Revised Final Program Environmental Impact Report  
for the MoVal 2040: Moreno Valley General Plan  
Update, Associated Zoning Text Amendments to  
Title 9 (Planning & Zoning) and Zoning Atlas  
Amendments, and Climate Action Plan

SCH # 2020039022

**Revised Final Program EIR  
April 3, 2026**

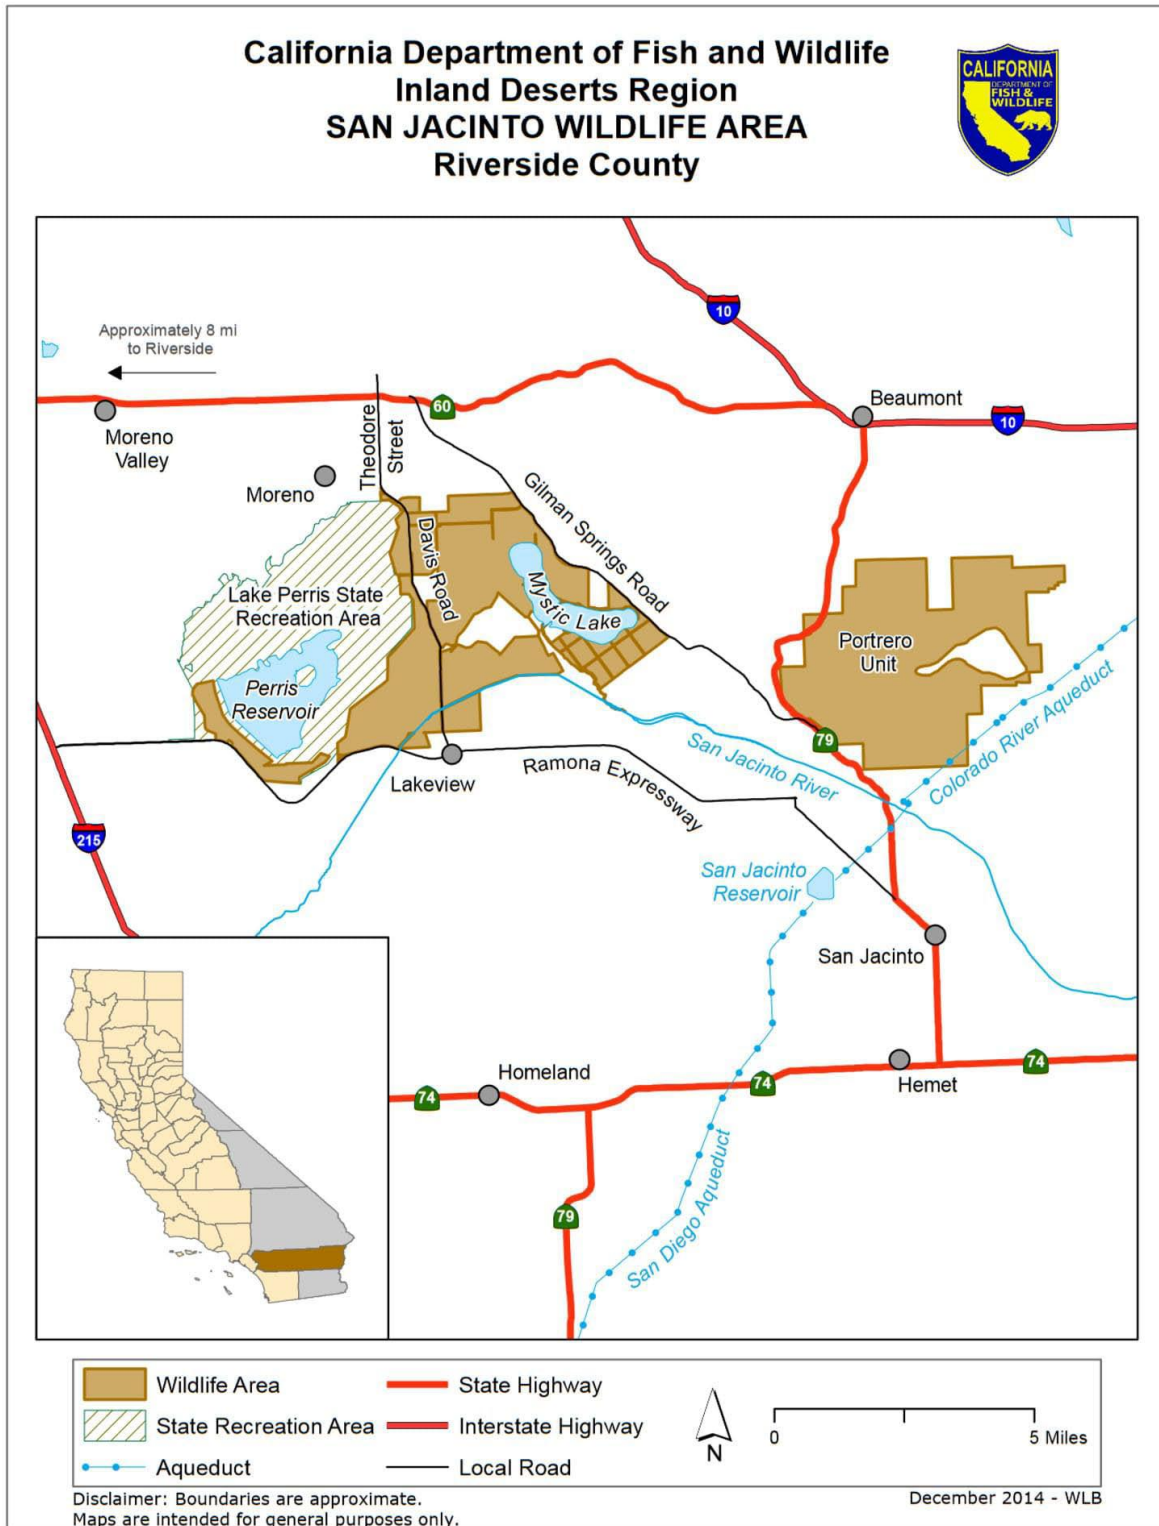
In Appendix A. Revised Draft Program EIR Notice of Preparation, Scoping Meeting Materials, and NOP Comments Exhibit 2 Planning Area, (Source City of Moreno Valley ArcGIS, 2018 and 2023), has a totally inaccurate map of the San Jacinto Wildlife Area (SJWA) despite the city having been provided correct versions several times. This problem is not limited to this location, but is inaccurate throughout much of the document. This Exhibit 2 doesn't even show that part of the SJWA is within Moreno Valley City limits. The Scoping Meeting slides of SJWA maps shared as part the meeting as well as part of the public's notice of the Revised General Plan Update 2040 GPU/CAP were inaccurate at the time of the meeting and the city was told so, but are again has included them with other documents related to the notice on this project.

The boundaries of the SJWA provided within the Revised Draft EIR have been adjusted since the Public Scoping Meeting held on Wednesday, August 14, 2024, to accurately reflect the latest available data for the SJWA provided by the CDFW Public Access Lands Dataset.<sup>19</sup> As such, no further response is warranted or required.

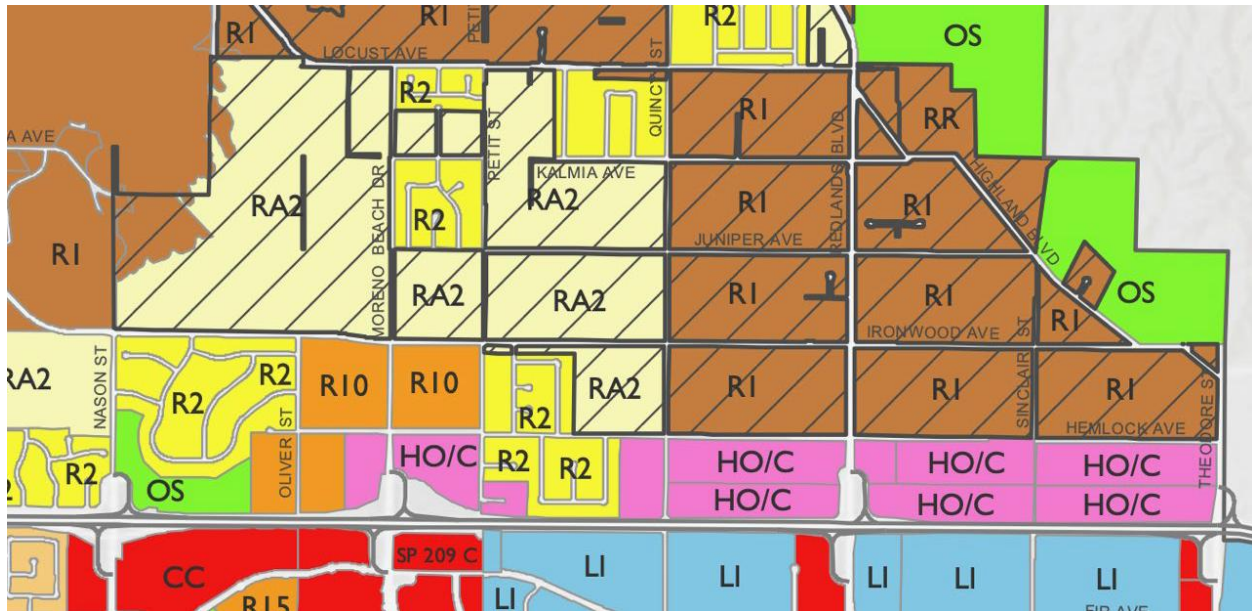
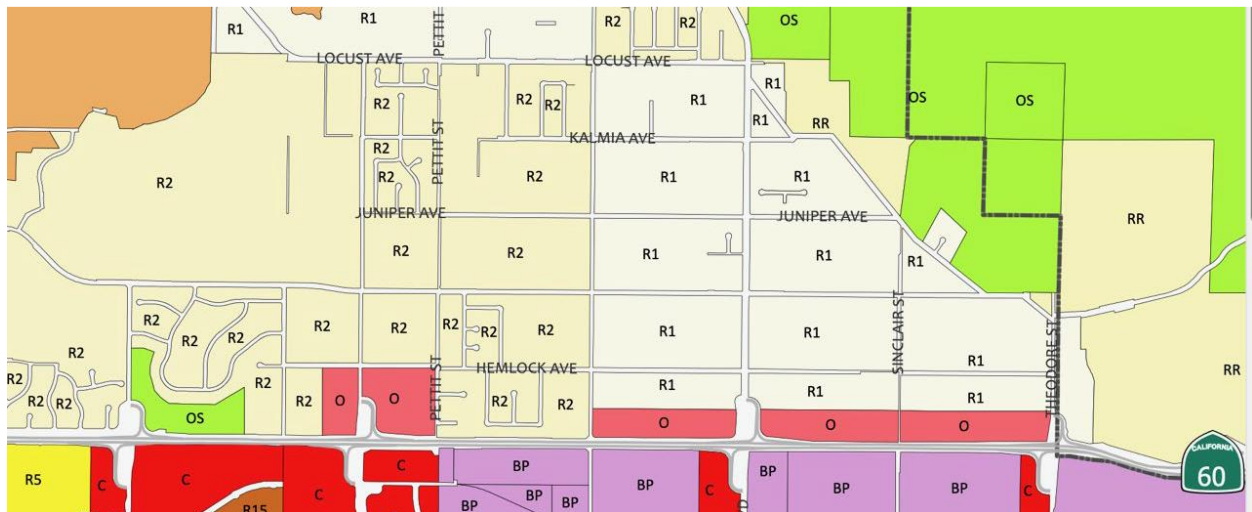
The zoning map found below is from the 2021 General Plan that the Courts told the city they had to set aside and not use. **You will soon be asked to simply rubber stamp the same 2021 zoning map again for General Plan Update (GPU).** As you can see the **Orange R-10 (ten units/acre)** is north of SR-60 and south of Ironwood Ave - on both sides of Moreno Beach Dr. R-1 is one unit per acre and R-2 is two units per acre. They also added C in pink for Commercial north of SR-60 which will significantly impact the R-2 homes in the middle of them — it was and currently is O for Office which has many fewer impacts on families.

Because the courts told the city to set aside the 2021 zoning we again **enjoy the zoning found below.** There is currently no R-10 in the NE and only O for Office just north of SR-60 which will impact existing families on R-2 in the middle much less than C for Commercial.

The above is the current Zoning in NE Moreno Valley which most in that area are in favor of maintaining. The map at the top was pushed Through In 2021 when NE Moreno Valley families had NO council member representing them because she had died. Please do Not Accept that it was approved by those representing the NE area.

**Figure 1.** The City of Moreno Valley and surrounding areas within 20 km with warehouses and potential future warehouse projects. Data from Warehouse CITY v1.23 (Phillips and McCarthy, 2024).

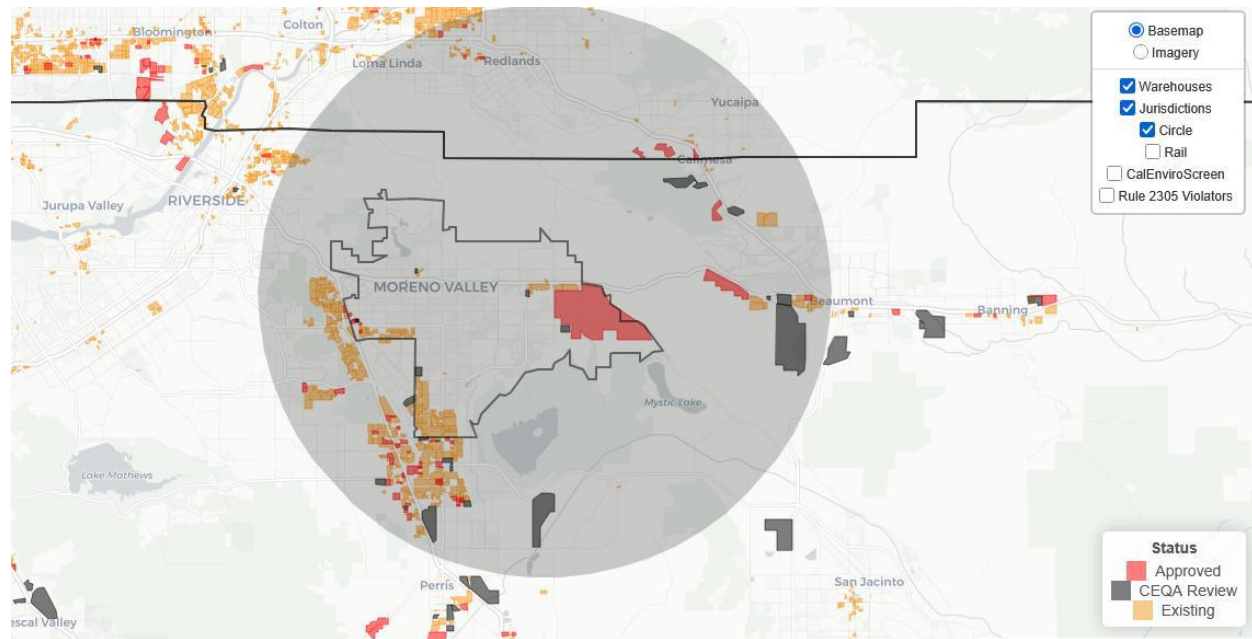
**Figure 1** shows warehouse existing and planned development around Moreno Valley in Beaumont, Perris, and other areas. Warehouses don't exist just within Moreno Valley and the industrial land use in the region will cause regional air quality, traffic, GHG, and low-quality jobs problems.

Fig. 1 Warehouses in MoVal and Other Areas within 15km (from 8/26/24 Comments)

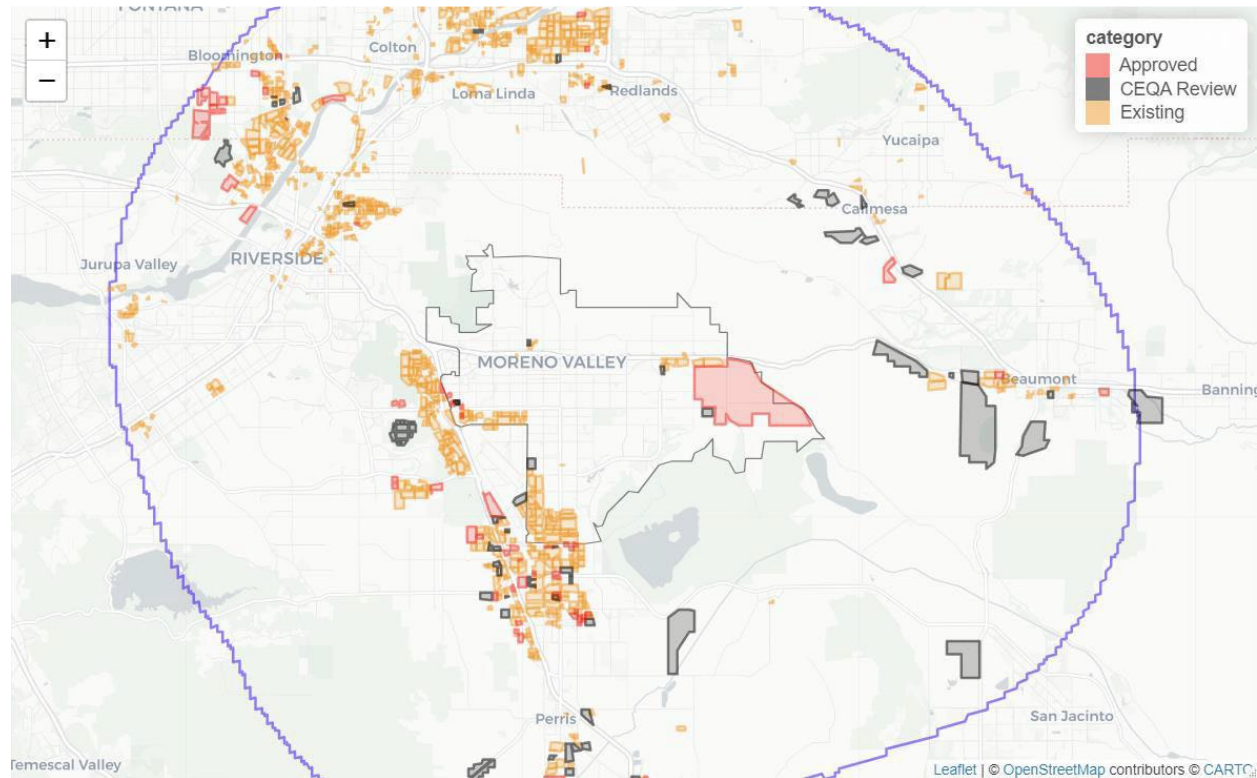
**(a)** This draft CAP does not clearly explain how the actions proposed to close the gap will fully reverse the existing and new amount of GHG emissions that come from approximately "1076 existing warehouses covering 13,000 acres ... and about 190,000 daily truck trips ... 64 approved warehouse projects ... and 71,000 truck trips ... and 58 warehouse projects under CEQA review ... and 87,000 truck trips." (My underlines, see Fig. 1 below and Mr. McCarthy comments, August 26, 2024) that will impact the Moreno Valley area. Please explain clearly and in sufficient detail in the body of the report your assumptions, modelling and treatment of these existing and upcoming GHG overwhelming emissions, and why such assumptions and treatment are valid. The current pollution and warehouses have already affected our air

quality and our health for years (with impacts clearly and emphatically explained in your draft EIR, digital pps. 142-144), and have caused traffic nightmares along the 60 and 215 freeways.

Fig. 2 Pollution Burden Percentile by Census Block in Moreno Valley (MV IRP, p. 44)

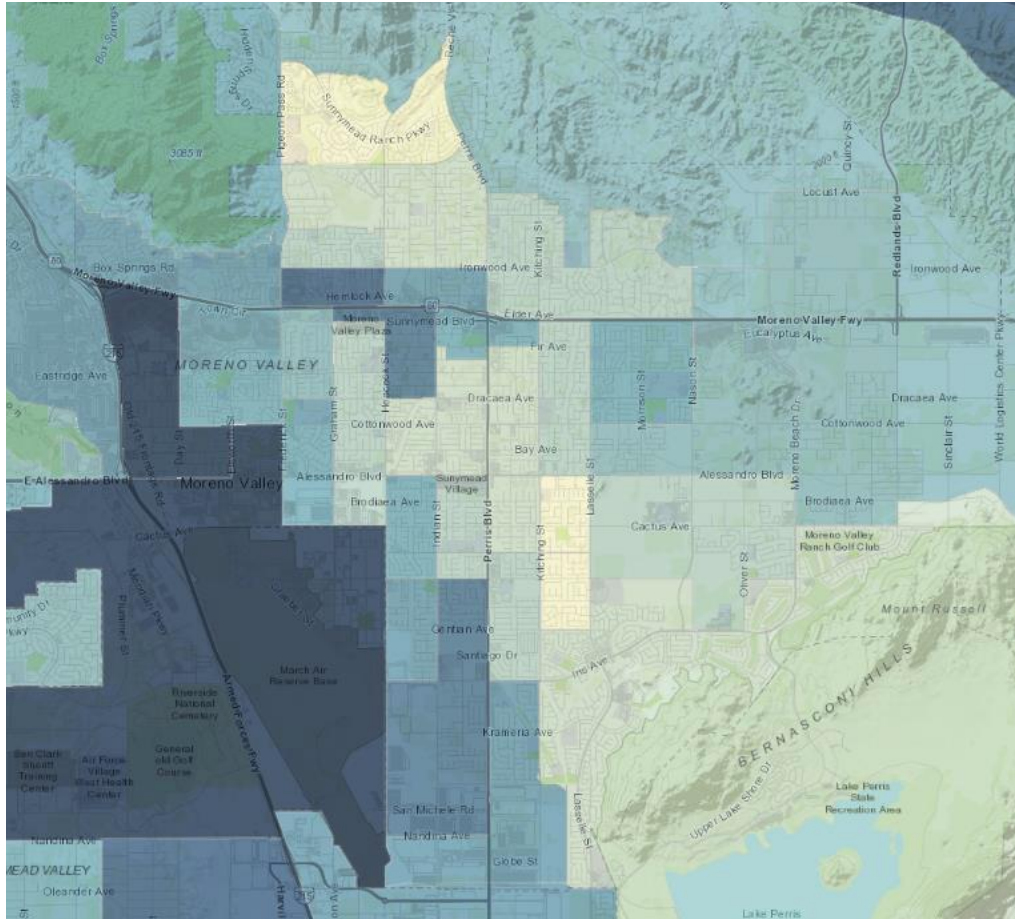
**4. Environmental Justice** - It is well chronicled in the news that the Inland Empire has one of the worst air qualities in the country, the American Lung Association gives routinely an F for air quality reports, and "Inland residents suffer higher rates of asthma and other ailments linked to air pollution" (The Press-Enterprise, July 30, 2025, p. 6). Although the logistics industry brings needed jobs to the Inland Empire, the pollution from diesels exhaust created by big trucks and freight trains connecting to warehouses is contributing to our failing air quality and health. Fig. 2 below shows the pollution burden percentile for Moreno Valley - you can see that more than 50% of the City has a burden of 50% or higher, which indicates an area that is heavily impacted by pollution and environmental burdens due to its "proximity to highways, industrial operations, and the nearby Air Force base" (MV IRP, p.43)

Fig. 3 Earth Observatory Website (accessed 8/12/25) - Where Warehouses are Built, Air Pollution Follows

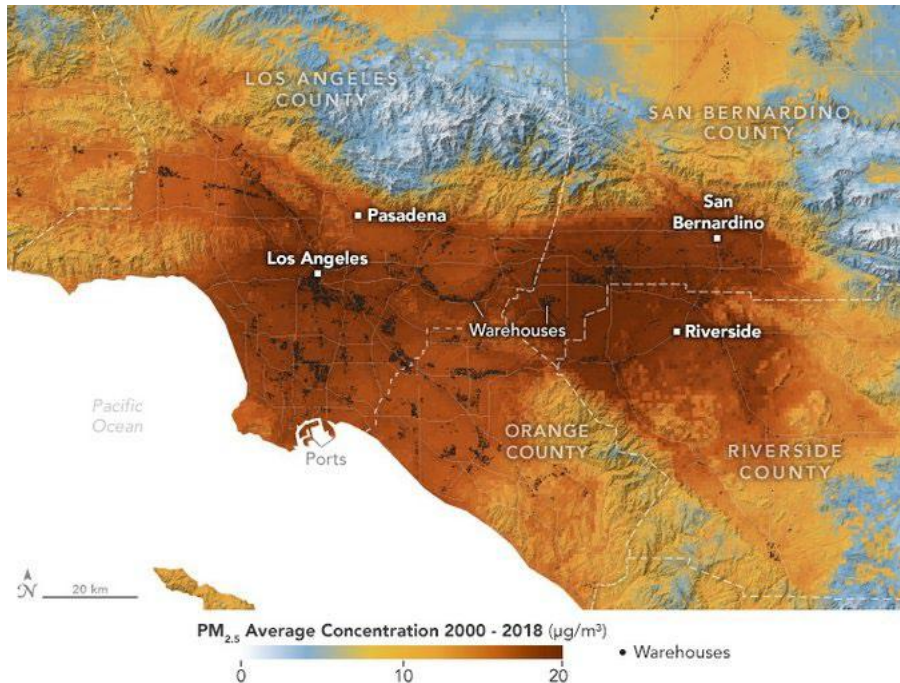
Furthermore, Fig. 3 below confirms what we already know, that "areas with large warehouses, or a large number of warehouses, ha[ve] higher levels of airborne contaminants than those with fewer or smaller warehouses" (The Press-Enterprise, July 30, 2025, p. A6). This proliferation of warehouses and its associated truck and freight rails are the "primary sources of pollutants like nitrogen oxides (NOx) and Particulate matter (PM), which disproportionately impact nearby [Disadvantaged Communities]", and there are already too many of those in the State.
